Our Ref: PSM5077-002L

7 December 2023

RE: HILLS OF GOLD WIND FARM-INDEPENDENT EXPERT ADVICE ON CONSTRUCTABILITY, SOIL AND WATER

Inset 10: Schematic cross sections through the TT embankment where it crosses the deeply incised drainage paths

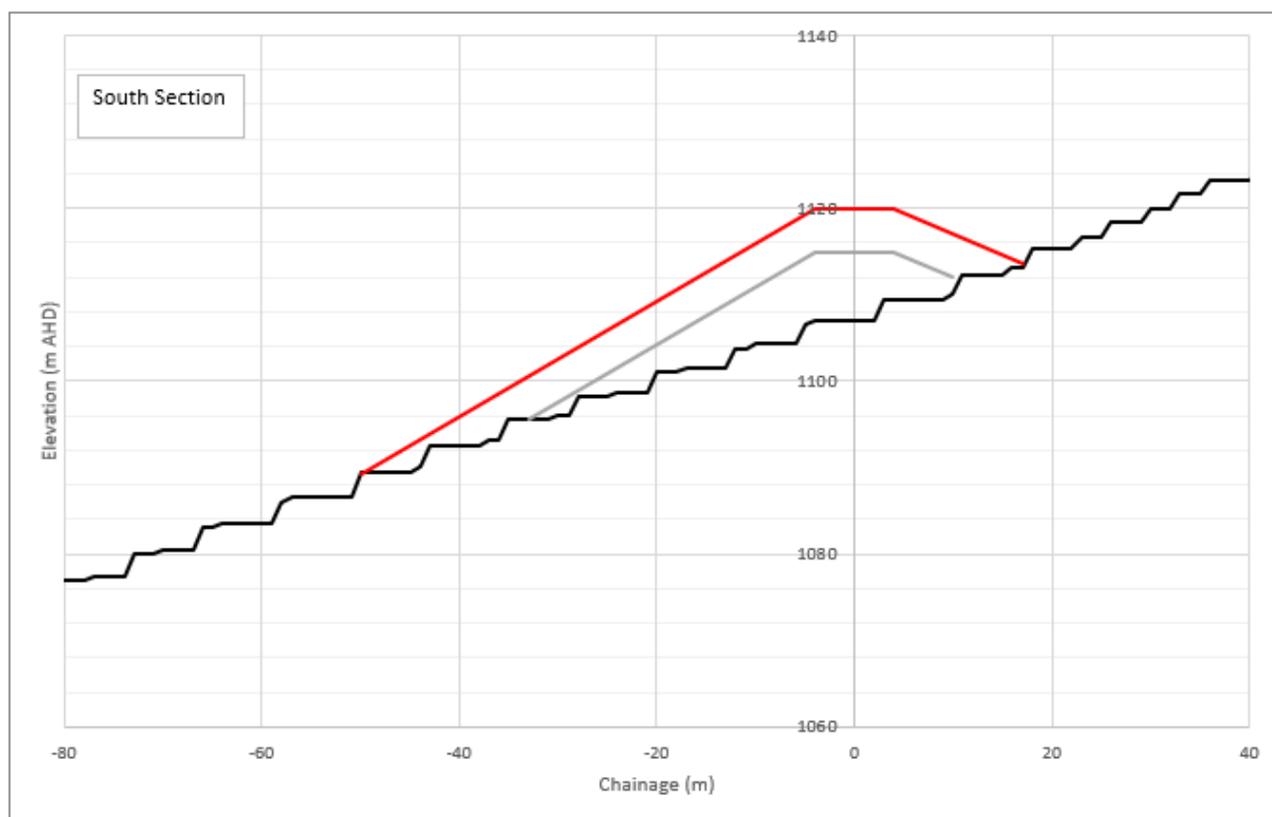
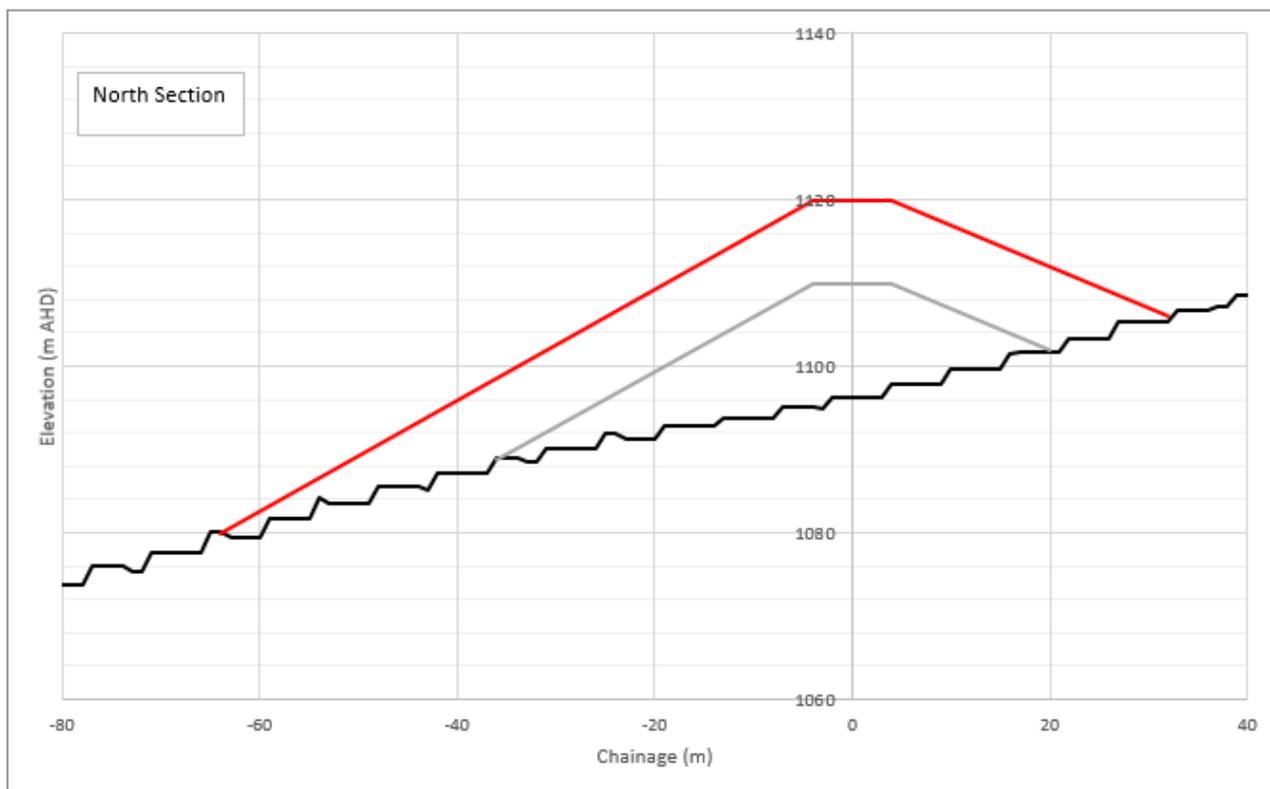
Inset 10 we present two cross sections through these drainage paths. As can be seen a 10 m to 20 m high embankment could be required across these valleys. The valleys themselves are steep with slopes of between 28% and 40%.

The downhill sides of the embankments will thus need to be constructed with batters steeper than the recommended 2H:1V and the use of retaining structures or select material (e.g. rockfill) is thus likely to be required. There are no details with regards the proposed approach to design and construct these steeper batters.

In any case the batters will be steep and potentially over 40 m long and thus present increased risk of erosion upon exposure. Rehabilitation will also be challenging. Should specialised erosion mitigation measures include sediment basins, these themselves would result in embankments with steep batters. It is not clear whether allowances have been made to include these within the disturbance footprint.

Overall, this emphasises the need for further details regarding the proposed earthworks design, erosion mitigation measures and surface water design measures associated with the TT.
